**Subject: Docket Nos. 50-361 and 50-362
Proposed Technical Specification Change Number NPF-10/15-516
Reduce the Minimum Boltup Temperature for Reactor Vessel Head
Bolts When They Are Tensioned
San Onofre Nuclear Generating Station Units 2 and 3**

AMENDMENT APPLICATIONS 199 AND 184

(PCN-516)

**DESCRIPTION AND SAFETY ANALYSIS
OF PROPOSED CHANGES NPF-10-516 and NPF-15-516**

SONGS 2 COOLDOWN RCS PRESSURE/TEMPERATURE
LIMITATIONS UNTIL 20 EPY
Remote Shutdown Operation

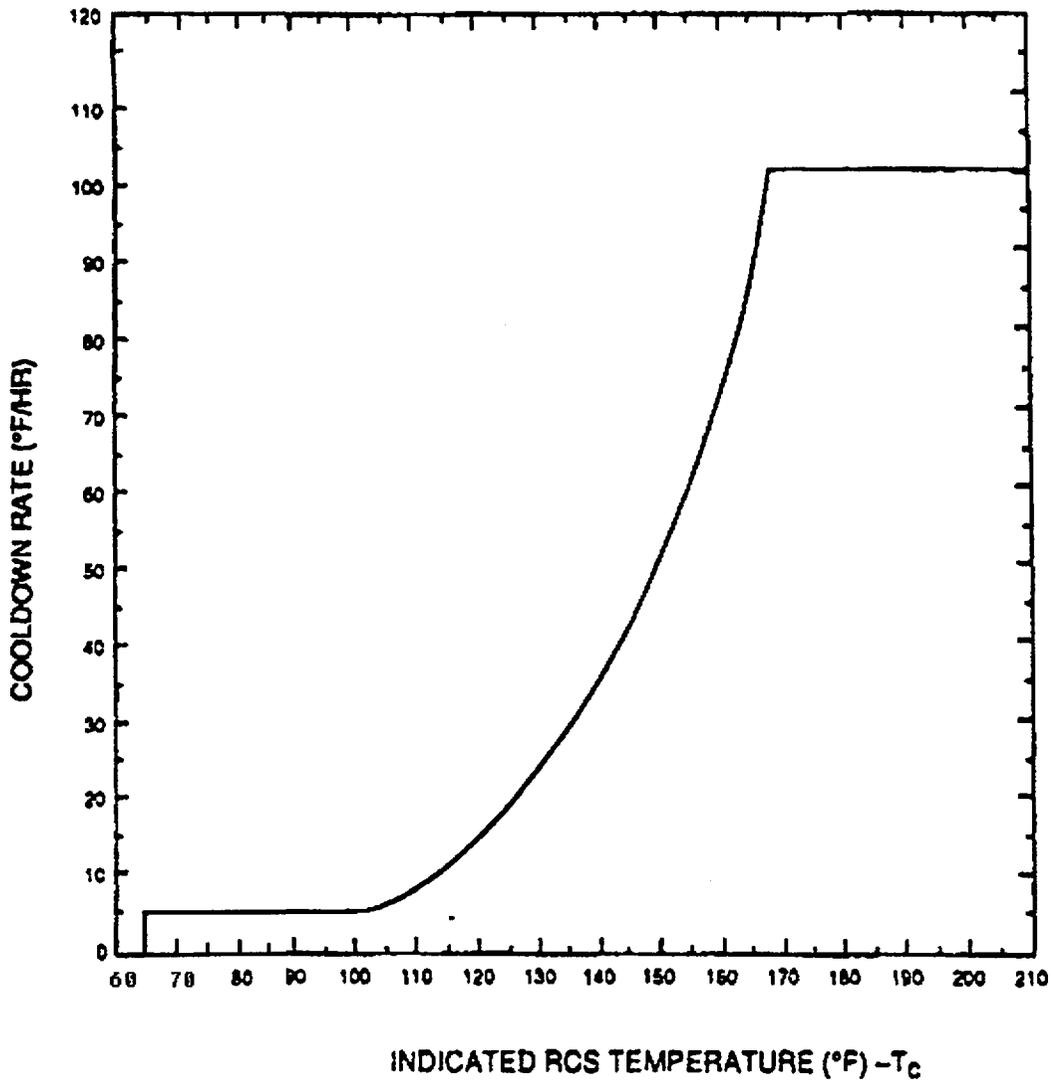
LCO Conditions "a" and "d", a footnote at page 3.4-5 and Figures 3.4.3-1 through 3.4.3-5 will be revised to reflect this new value. The Pressure-Temperature curves on Figures 3.4.3-1 through 3.4.3-5 will be extended from 86°F to 65°F. During operation at temperatures between 86°F and 65°F, the pressure limit change is negligible. Additionally, the TS bases will be updated to reflect the basis for the MBT of 65°F.
